CODE REFERENCES:

2007 CBC Section No. 2305.2

ISSUE:

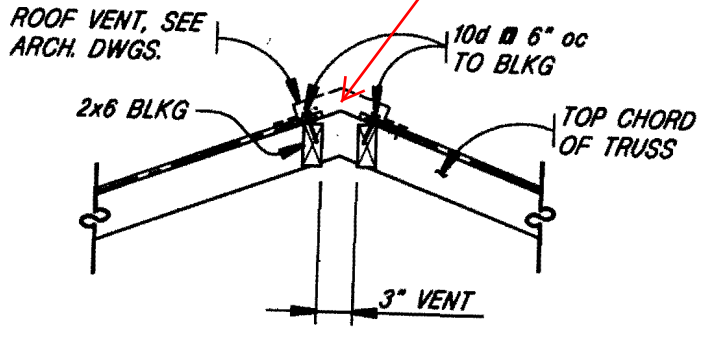
As indicated in the attached diagram, the engineer has proposed a continuous 3-inch gap at the ridge of a simple gabled end roof system to allow for attic ventilation.

Does this create an open ended diaphragm ? The diaphragm shear at the ridge location is zero. "Something" does not "feel" right !!

Plywood is held back 1.5 inches on each side.
